STAFF REPORT

HEARING DATE: January 3, 2023
(Continued from December 13, 2022)

SUBJECT: H-2022-0046
Sessions Parkway – MDA, PP

LOCATION: 2700 N. Eagle Rd., in the NW 1/4 of
Section 4, T.3N., R.1E.
Parcel # S1104233650

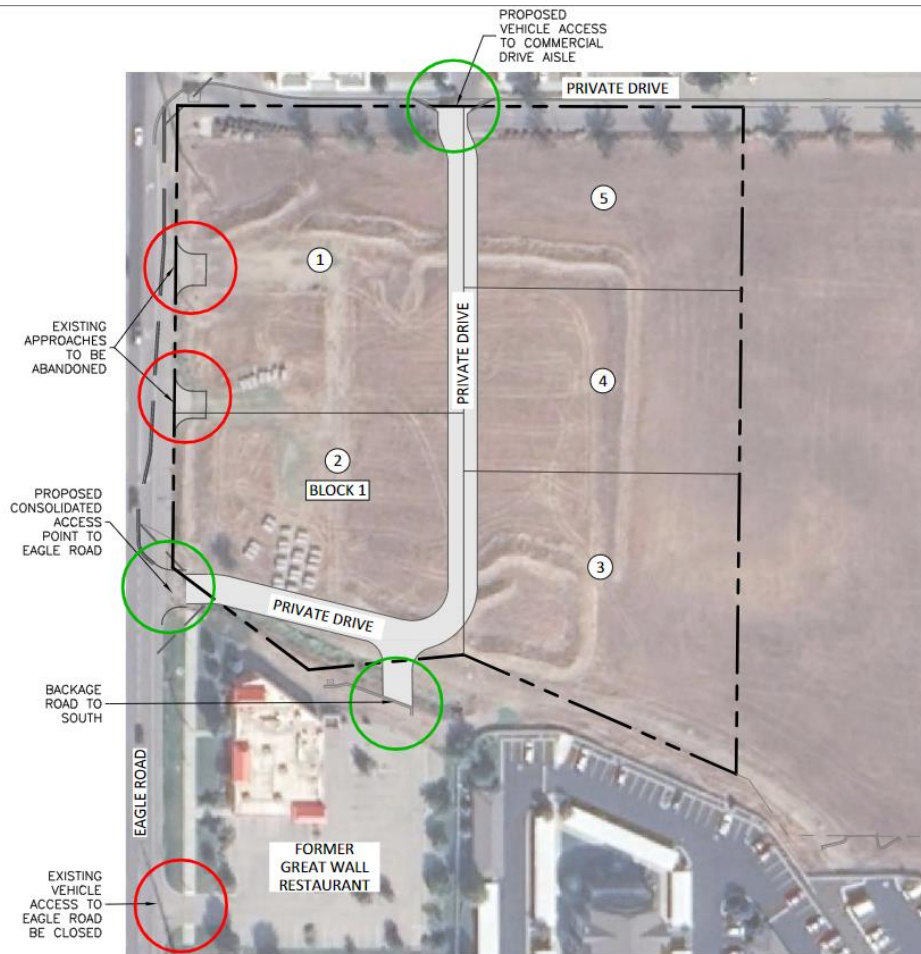
proposed to be removed and replaced with one (1) new right-in/right-out driveway access on the abutting property to the south as depicted on the plans and as shown below.

Per UDC [11-3H-4](#), the use of existing approaches via the state highway are not allowed to continue if the intensity of the use increases. With the change in use to commercial, the intensity of the use will increase; therefore, the existing approaches are not allowed to remain and must be abandoned and removed as proposed. New approaches directly accessing a state highway are only allowed at the section line road and the half mile mark between section line roads, which does not apply in this case. **City Council may consider and approve modifications to the standards in UDC 11-3H-4 upon specific recommendation of the Idaho Transportation Department (ITD) or if strict adherence is not feasible, as determined by City Council.**

ITD issued a [letter](#) of acceptance of the revised traffic striping conceptual drawings, dated November 13, 2019, for SH-55/Eagle Rd. from River Valley St. to approximately 1,500 feet north for the proposed right-in/right-out access via Eagle Rd. The letter states the drawings address all of ITD's safety concerns but only acknowledges the acceptance of the conceptual plan – final approval of the proposed access and associated improvements is determined once all documentation has been provided and the permit is signed. **Final approval of the access has not yet been granted by ITD.**

B. Proposed Conceptual Development Plans (EX1.0 and EX2.0) AND Ped Access Plans (EX1.1 and EX2.1) - REVISED

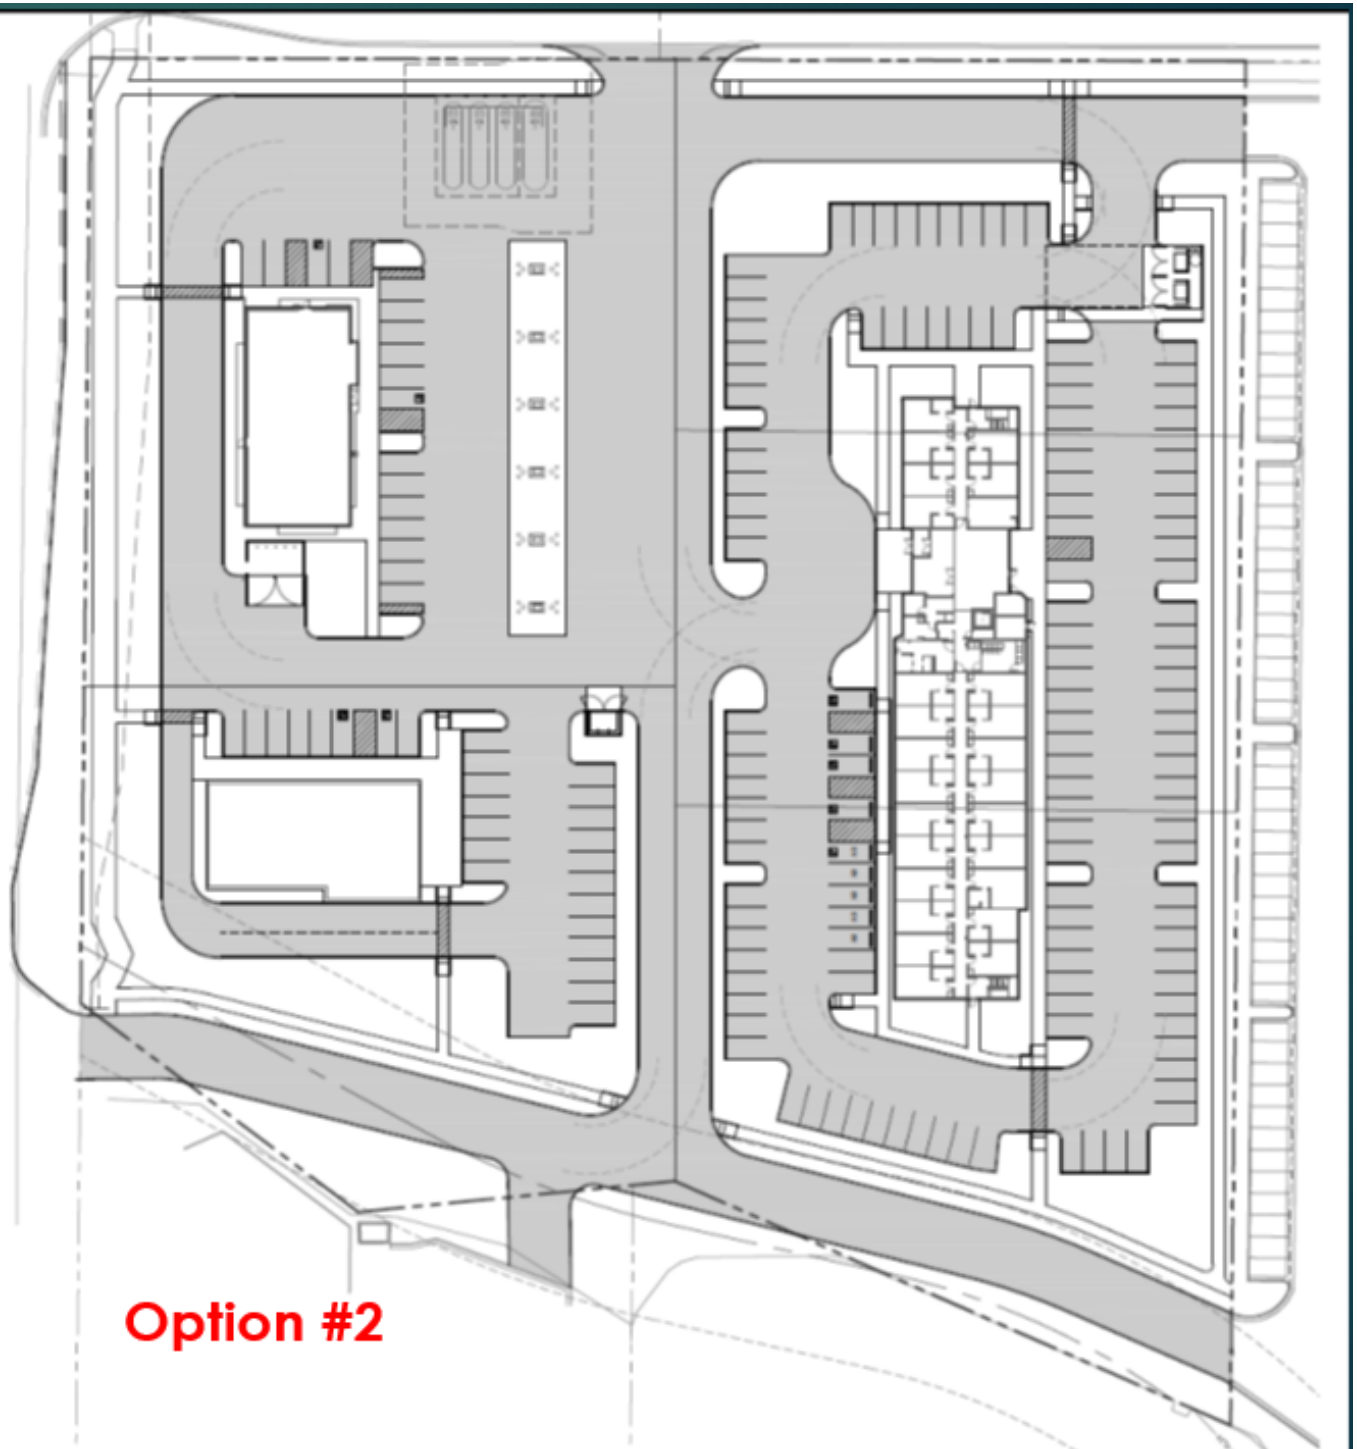
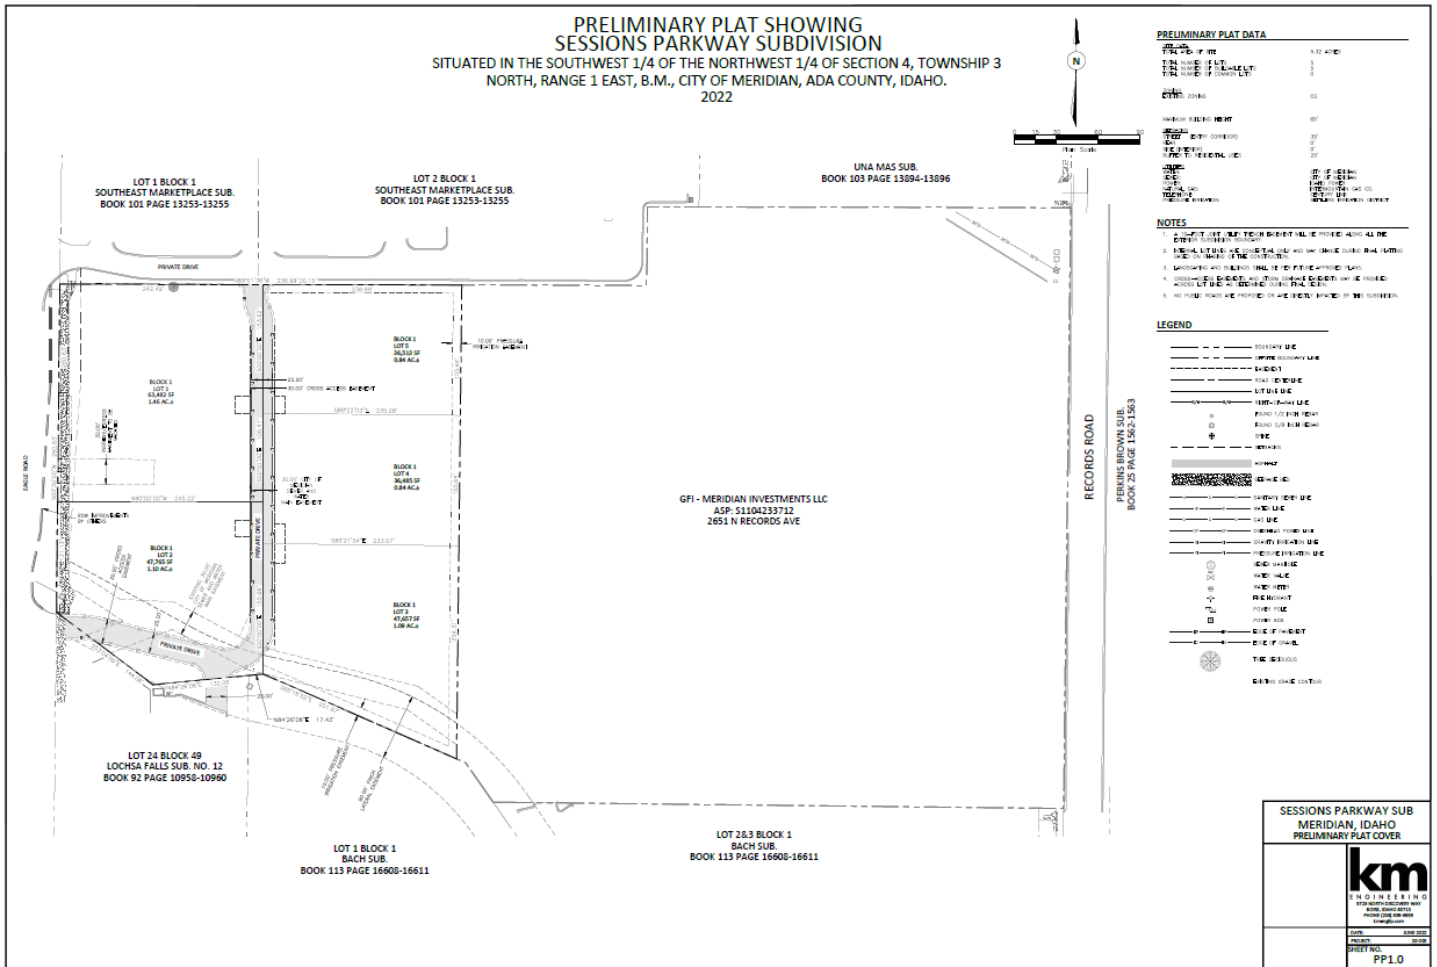
To ensure retail commercial uses don't exceed 50% of the development area and for a transition in uses, Staff recommends the concept plan is revised to depict non-retail commercial, office and/or civic uses for a minimum of 50% of the development area between the residential and retail commercial uses. The plans have not been updated to reflect this request however, the second concept plan does depict a hotel site which could limit the amount of retail that could develop on the site. The new DA should restrict the amount of retail on this site unless Commission and Council find this development shouldn't be further restricted because this property is part of a larger MU-R designated area.

- **Depict non-retail commercial, office or civic uses for a minimum of 50% of the development area on ~~Exhibit EX1.0~~ concept plan option 1, unless Commission or Council find this isn't applicable because this property is part of a larger MU-R designated area. This doesn't apply if the property develops with the hotel as proposed in ~~exhibit EX2.0~~ concept plan option 2.**

- **On concept plan option 1, ~~labeled as EX1.0~~, some or all of the buildings along the eastern boundary should be rotated and/or relocated and a shared plaza area/green space added to a more central location within the development for better integration, including a central pathway connection to the open space and front pad sites.**

- **If the site develops consistent with concept plan option 2, ~~labeled as EX2.0~~, the applicant shall construct a 5-foot sidewalk on the east boundary and provide a decorative crosswalk across the drive aisle of the multi-family portion of the development (SWC of the Village Apartments) to enhance pedestrian connectivity.**

Option 1 includes expanded open space and a plaza area between the center and south building pads. There will be seating and awnings included in this plaza, which will be detailed in a rendering submitted for the Council hearing.

Option 2 includes an open space area at the NW corner of the hotel area (to the east of the drive aisle) and will include a gazebo and seating, a couple of other seating areas and a pedestrian walkway on the east have also been added.

D. Landscape Plan (date: June 2022)

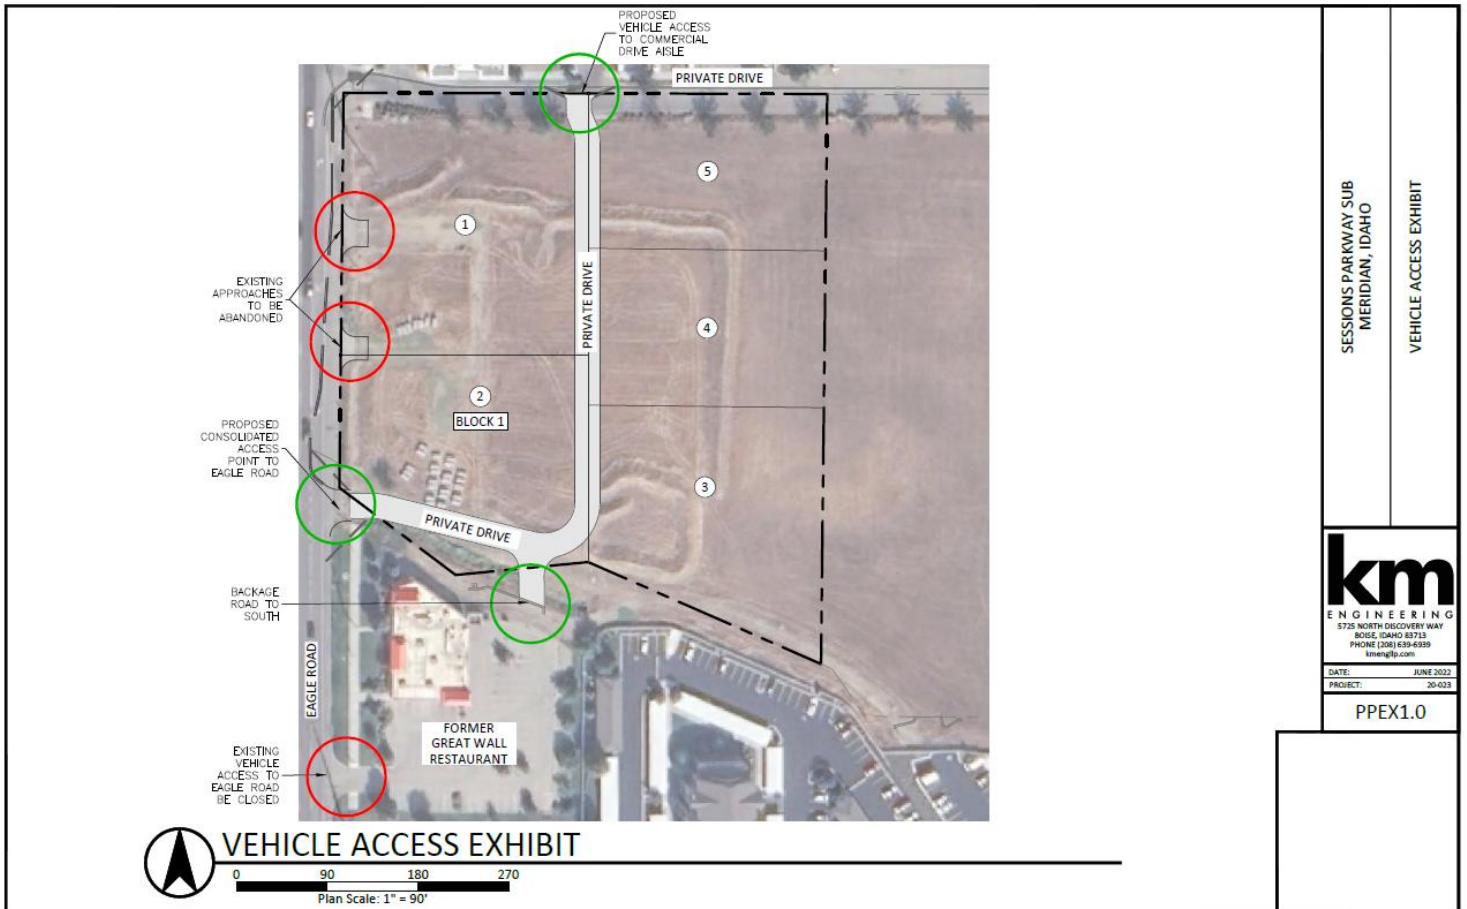
3. The landscape plan depicted in Section VII.D shall be revised with submittal of the final plat, as follows:
 - a. Depict landscaping within the 25-foot wide buffer along the eastern boundary of the site adjacent to residential uses in accord with the standards listed in UDC [11-3B-9C.1](#); and safe pedestrian connections between commercial and residential uses as set forth in UDC [11-3B-9C.3](#). *Construction of the buffer may take place with lot development.*

- b. Depict landscaping within the 35-foot wide street buffer along N. Eagle Rd./SH-55 in accord with the updated standards listed in UDC [11-3B-7C.3](#); and pedestrian lighting and landscaping consistent with the Eagle Road Corridor study per UDC [11-3H-4C.3](#).
